## New Jersey Transit 31LFW: Exhaust Cradle Replacement

**Issue:** Exhaust cradle may have corrosion.

**Reason/ cause:** Inadequate protective coating.

**Solution:** Replace exhaust cradle as required per this work instruction.

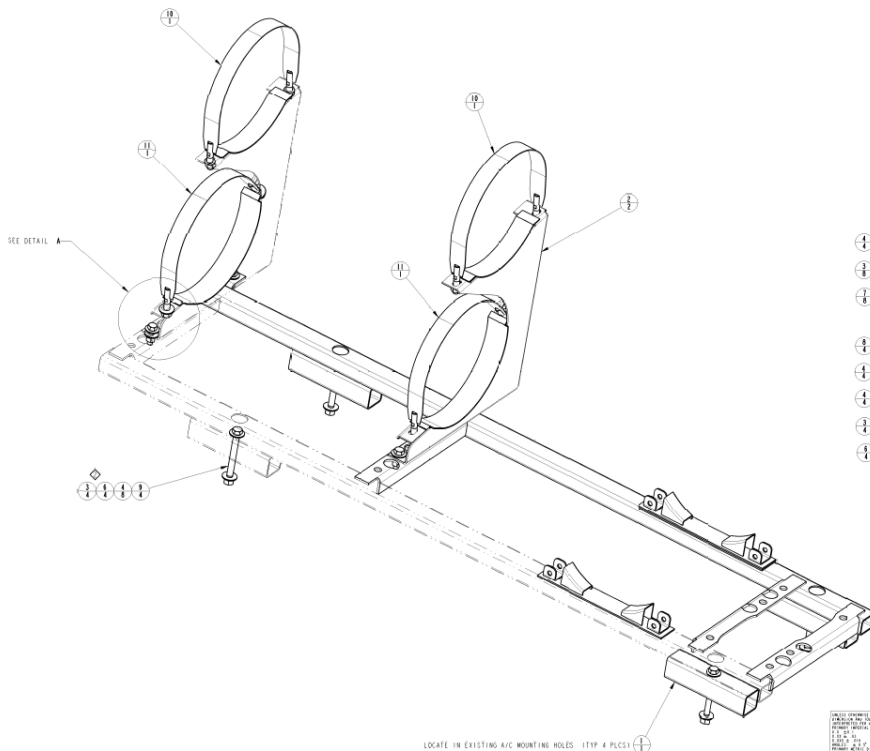
9. Disconnect exhaust clamps shown on the drawing below.

Loosen this clamp so the exhaust pipe can be slide up in order to separate it from the muffler.

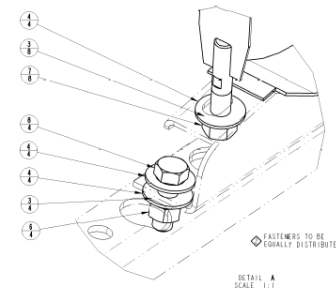
14. Remove exhaust components from cradle. Replace DPF and SCR mounting straps (see item 10 and 11 below) if they are not stainless steel. Replace any components if damaged. See part numbers of exhaust cradle and mounting hardware below.
